SUBJECT: ISSUANCE OF AMENDMENT NO. 74 TO FACILITY OPERATING LICENSE NO. NPF-12 - VIRGIL C. SUMMER NUCLEAR STATION, UNIT NO. 1, REGARDING FRESH FUEL AND SPENT FUEL STORAGE (TAC NO. 67811)

Amendment No. 74  
License No. NPF-12

SAFETY EVALUATION BY THE OFFICE OF NUCLEAR REACTOR REGULATION  
SUPPORTING AMENDMENT NO. 74 TO FACILITY OPERATING LICENSE NO. NPF-12  
SOUTH CAROLINA ELECTRIC & GAS COMPANY  
SOUTH CAROLINA PUBLIC SERVICE AUTHORITY  
VIRGIL C. SUMMER NUCLEAR STATION, UNIT NO. 1  
DOCKET NO. 50-395

FIGURE 3.9-1 MINIMUM REQUIRED FUEL ASSEMBLY EXPOSURE AS A FUNCTION OF INITIAL ENRICHMENT TO PERMIT STORAGE IN REGION 2

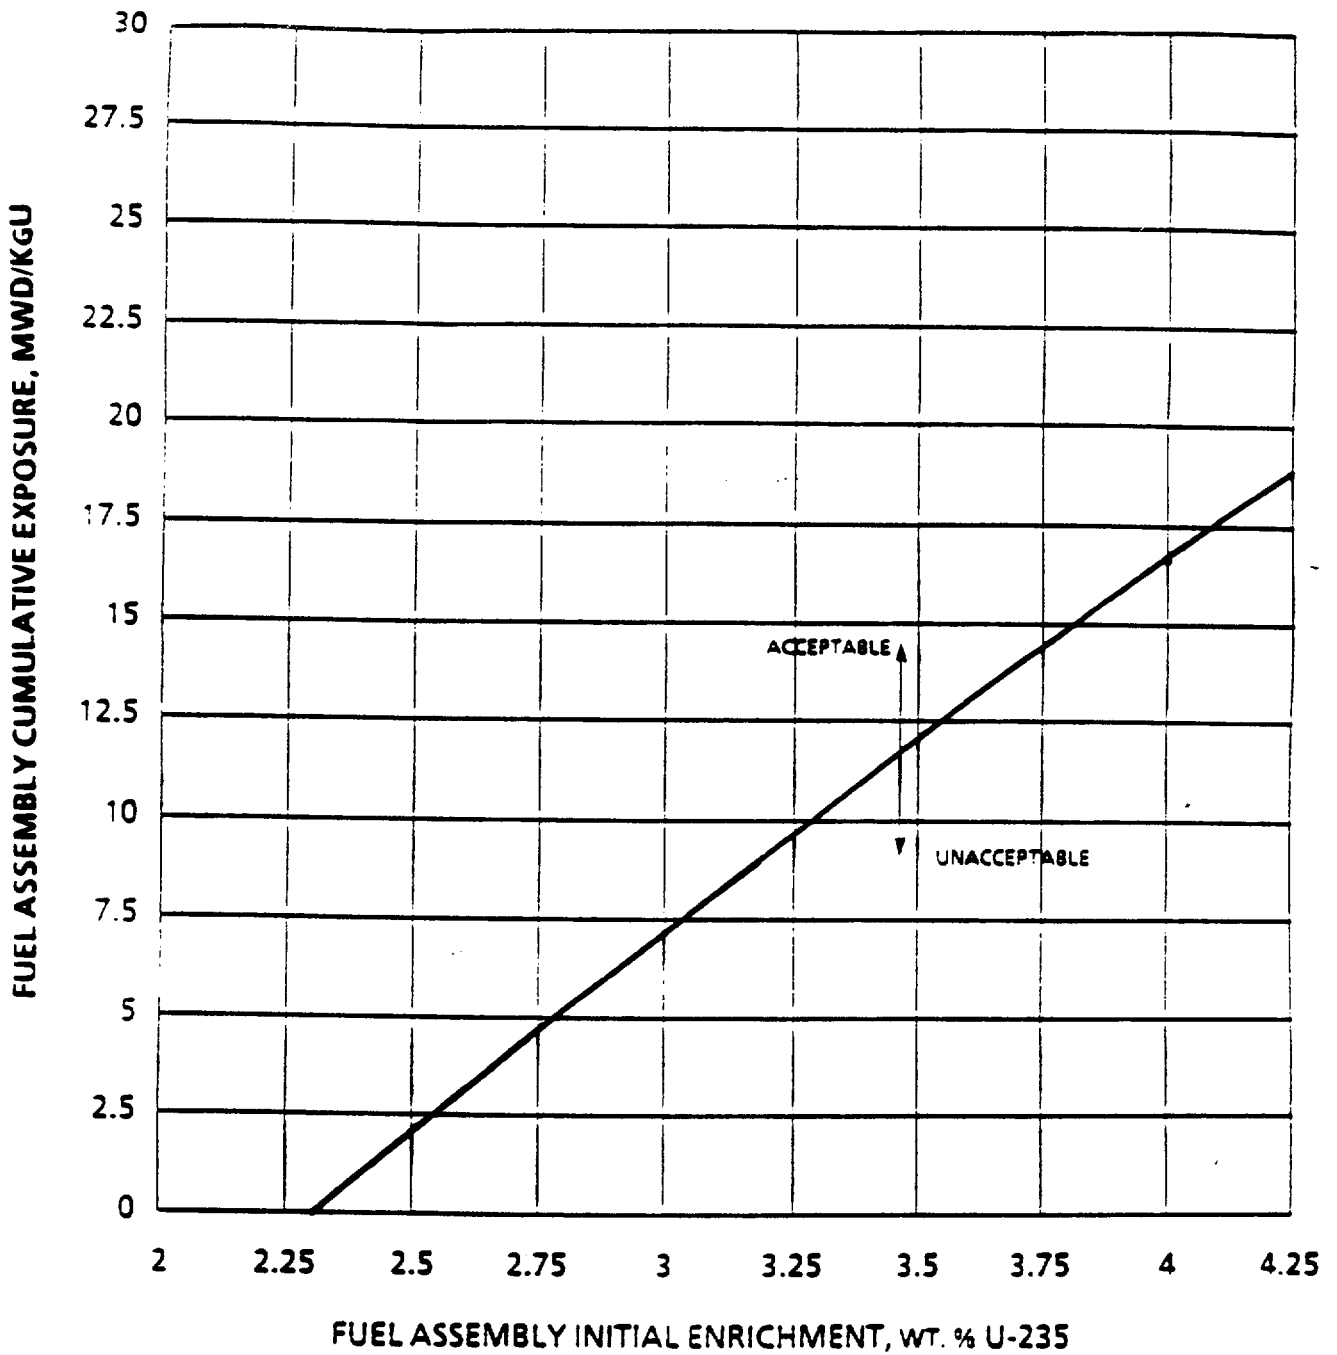
The amendment changes the Technical Specifications by revising Figures 3.9-1 and 3.9-2 of Section 3.9.12. These figures establish the minimum required fuel assembly exposure as a function of initial enrichment to permit storage of fuel assemblies in Regions 2 and 3 of the spent fuel assembly storage racks. In addition, the amendment revises Sections 5.3.1 and 5.6 of the Technical Specifications in terms of maximum initial enrichment of U-235 and minimum required burnup for Regions 2 and 3 of the spent fuel pool.

The purpose of the proposed amendment is to modify Figures 3.9-1 and 3.9-2 of Section 3/4.9.12. These figures depict the acceptable and the unacceptable values of fuel assembly exposure (i.e., burnup), as a function of fuel enrichment, to permit storage in Regions 2 and 3 of the spent fuel pool. The proposed changes to Technical Specifications 5.3.1 and 5.6.1.1 limit the maximum enrichment to 4.25 weight percent (w/o) U-235 and require a minimum burnup of 19,000 MWD/MTU (megawatt-days per metric ton uranium) for fuel stored in Region 2 of the spent fuel pool and 39,750 MWD/MTU for fuel stored in Region 3 of the spent fuel pool. The proposed changes to TS 3.9.12, 5.3.1, and 5.6 are to reflect revised storage limitations for the mix of LOPAR and the Westinghouse Vantage 5 fuel to be utilized in the core during the fifth cycle at the Summer Station and for the Vantage 5 fuel that will be used in all subsequent cycles.

steel cells, one for each stored assembly. The licensee has proposed that Region 1 accept freshly discharged fuel assemblies with enrichments up to 4.25 w/o U-235 while Regions 2 and 3 accept assemblies with up to 4.25 w/o U-235 initial enrichment provided they have burnups sufficient to meet criticality limits. These burnups are proposed as 19,000 MWD/MTU and 39,750 MWD/MTU for Regions 2 and 3, respectively. Regions 1 and 2 are poisoned, i.e., contain fixed boron absorbers. Present TS Section 5.6 allows fuel with an enrichment of 4.3 w/o U-235 and requires a minimum burnup of 20,000 MWD/MTU for Region 2 and 42,000 MWD/MTU for Region 3 of the spent fuel pool.

The staff has reviewed the criticality analyses for both the spent fuel racks of Regions 1, 2 and 3 and for the fresh fuel racks. Since the results meet the staff's criteria for a spent fuel peak of  $k_{eff}$  less than 0.95 (for unborated water) including uncertainties and the staff's criteria for fresh fuel racks ( $k_{eff}$  less than or equal to 0.98 in the low density moderator region and  $k_{eff}$  less than or equal to 0.95 in the high density region), the staff concludes that the proposed changes to Figures 3.9-1 and 3.9-2 of TS 3.9.12 and the proposed changes to TS 5.3.1 and 5.6 are acceptable.
